New Fairfield High School
State Project #: 091-0044N
Technology Equipment – Addendum #1
March 10, 2023

New Fairfield
High School &
Pool Locker
Rooms

ELECTRICAL DETAILS

E-514

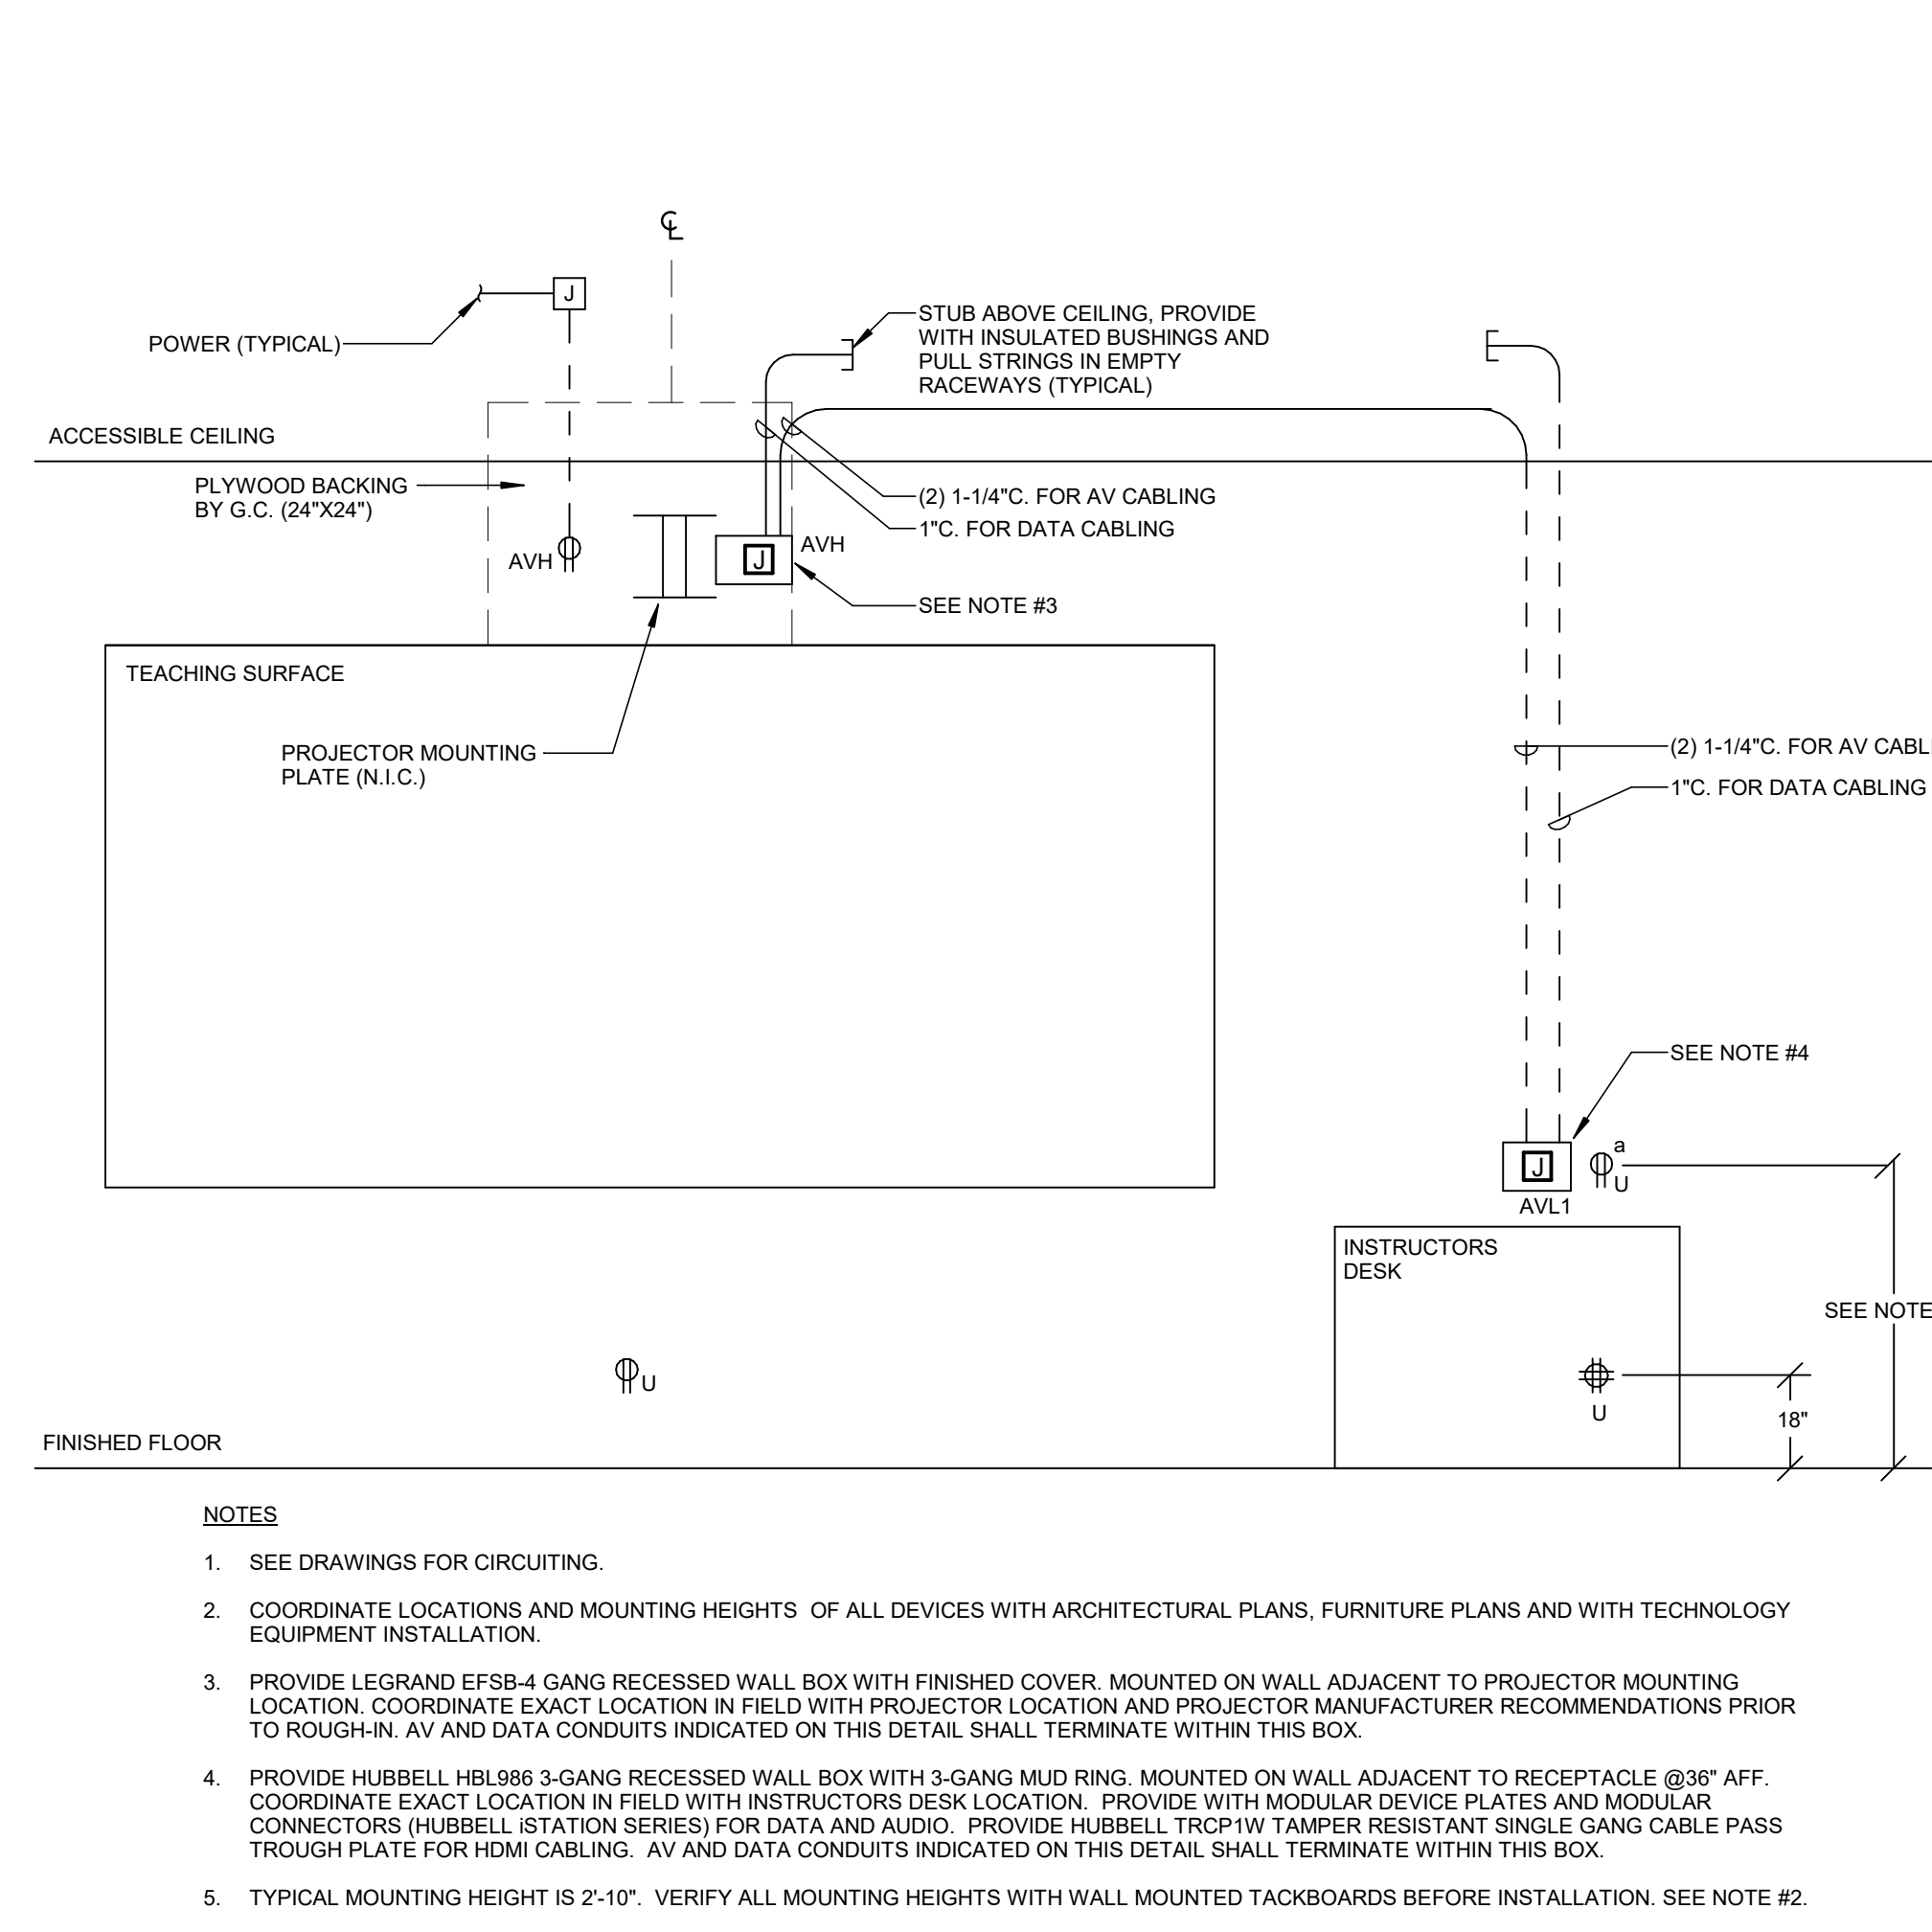
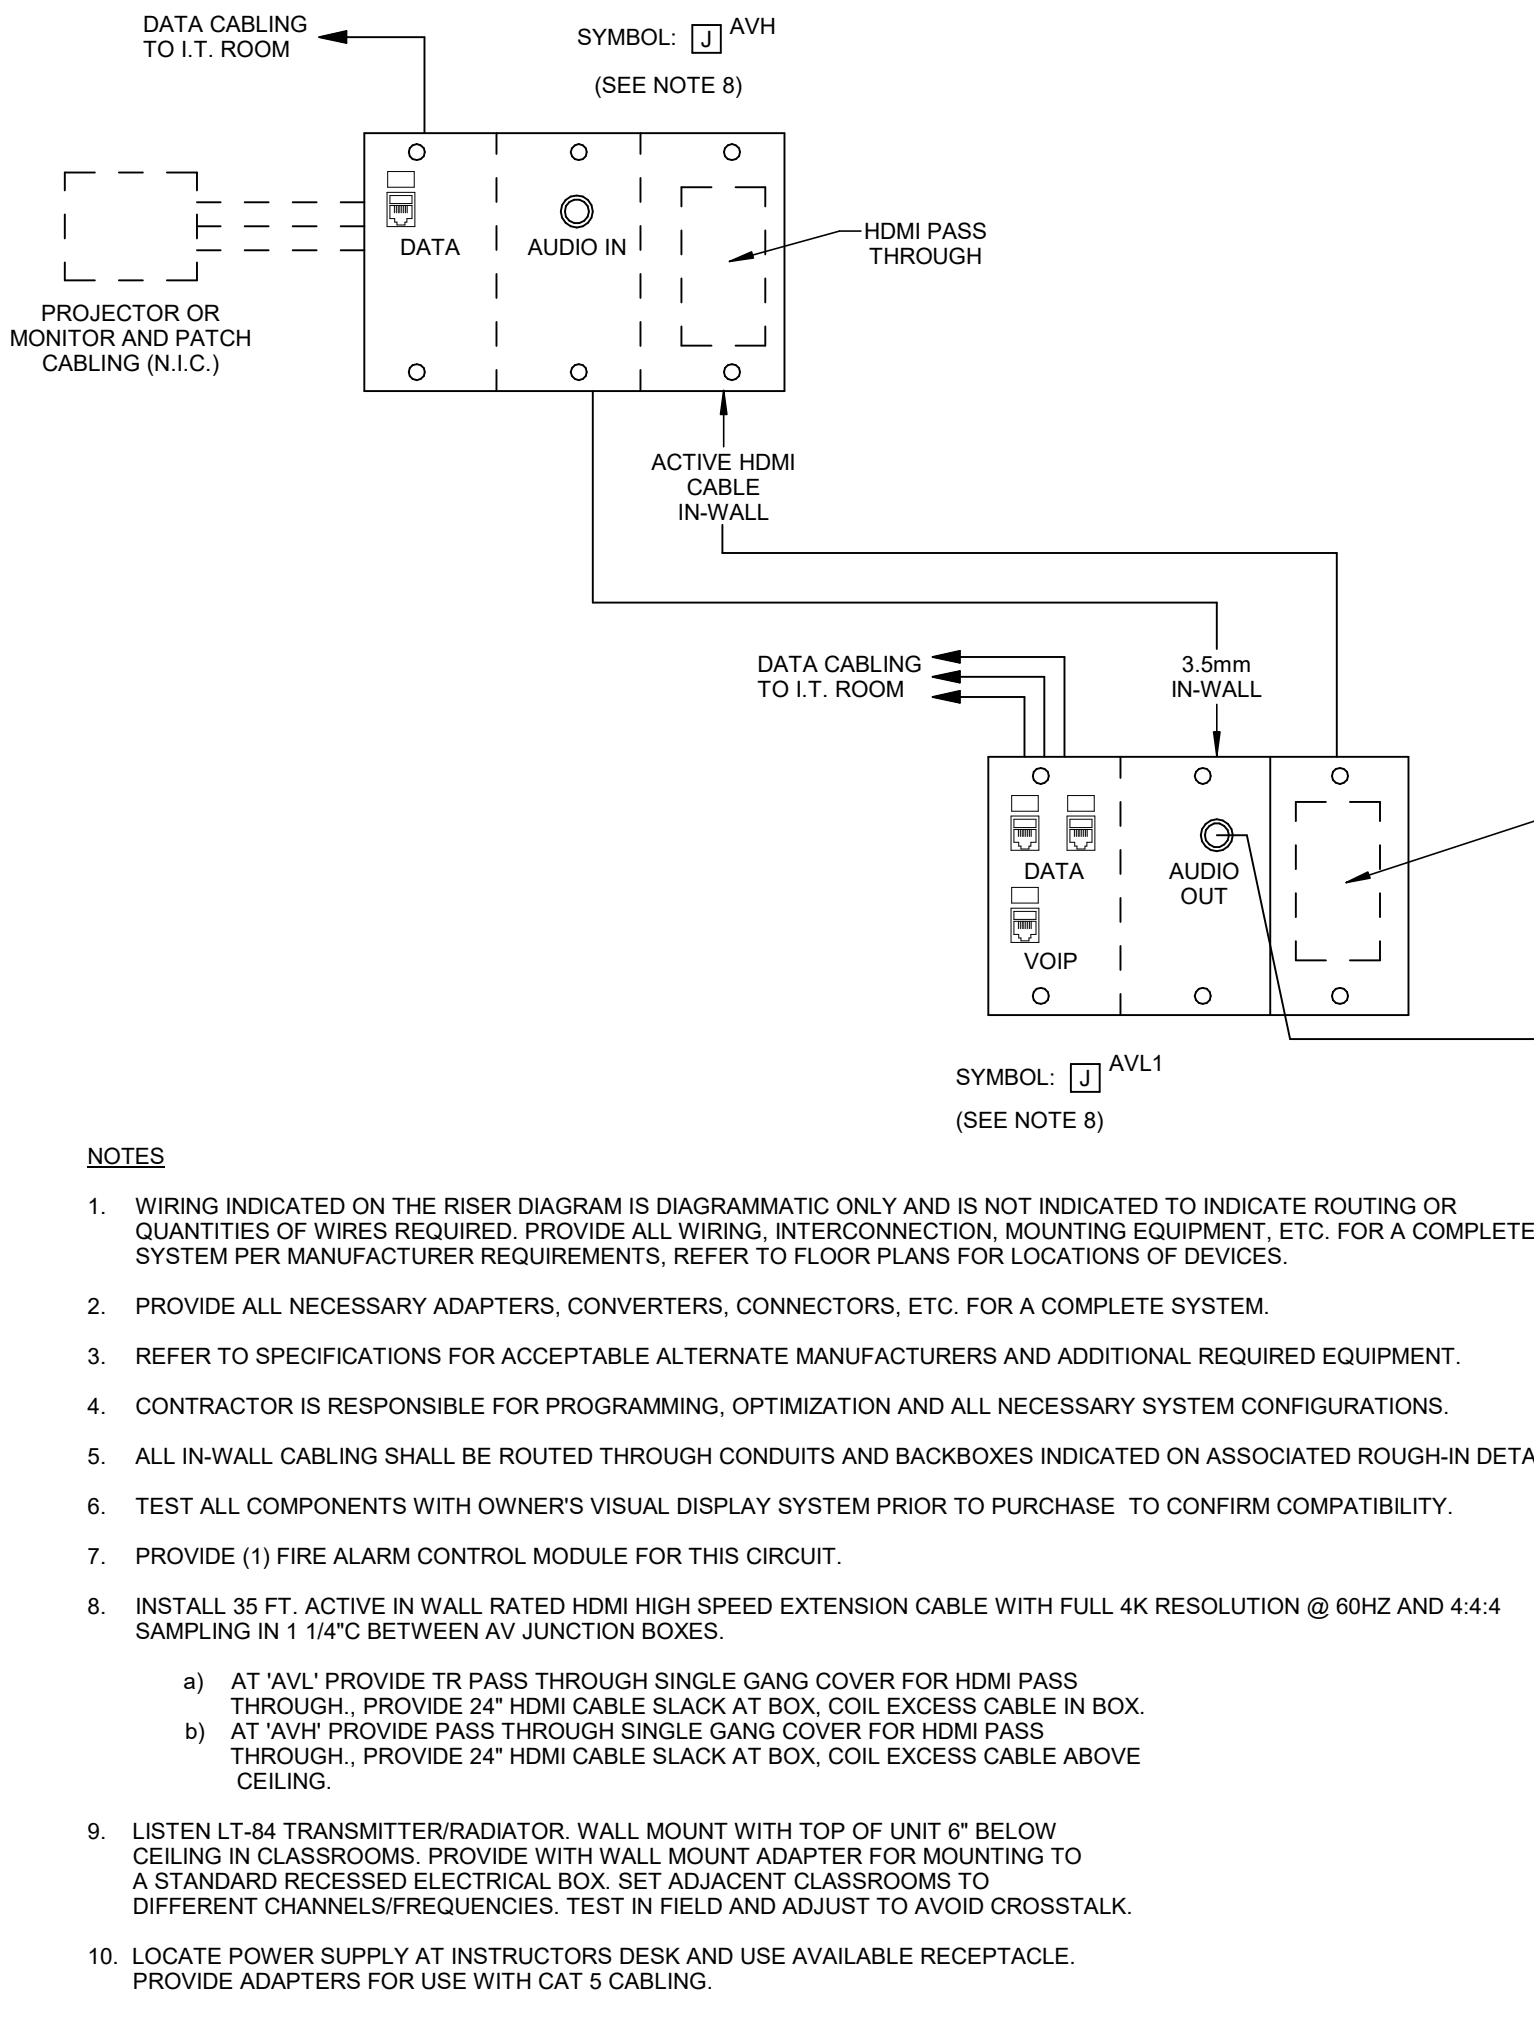
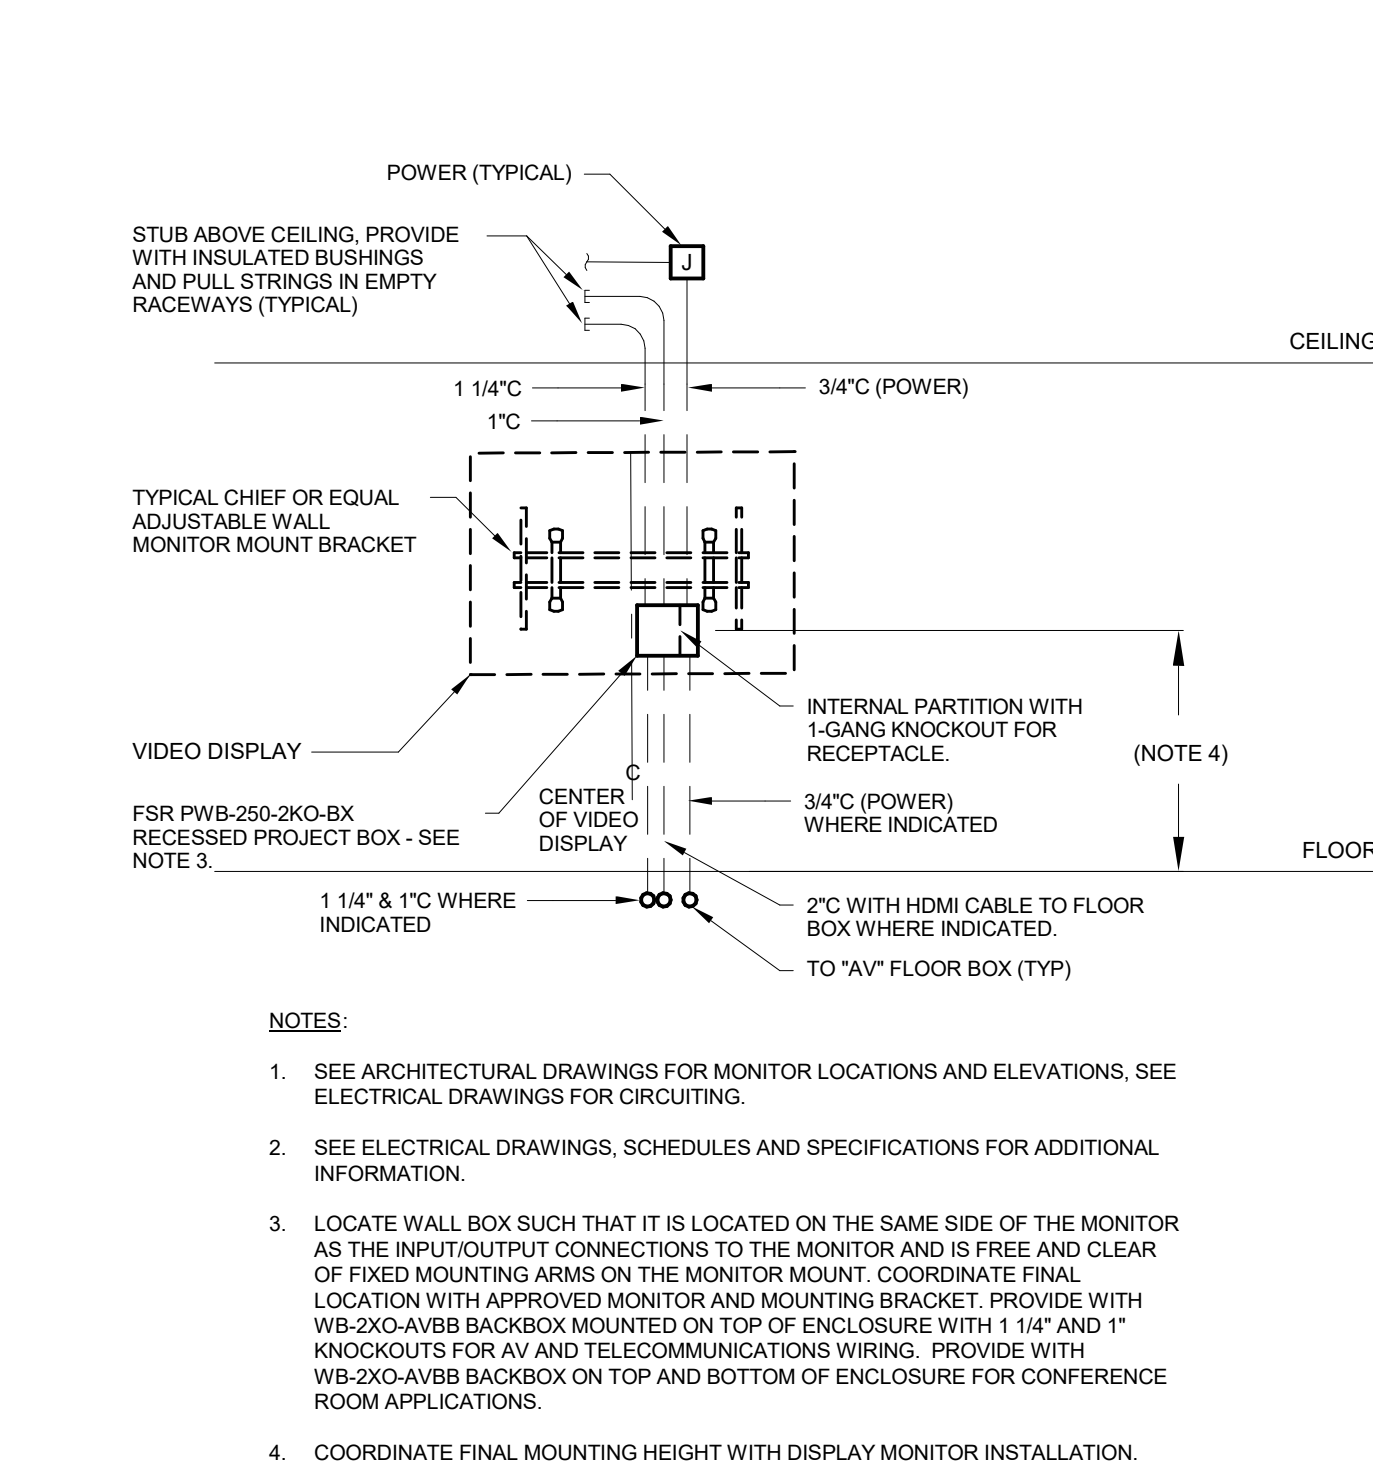
Q4: Can we please have a wiring diagram for TE1.1 - TE1.10

A4: *See attached sheet E-514 that is part of the base construction documents package.*
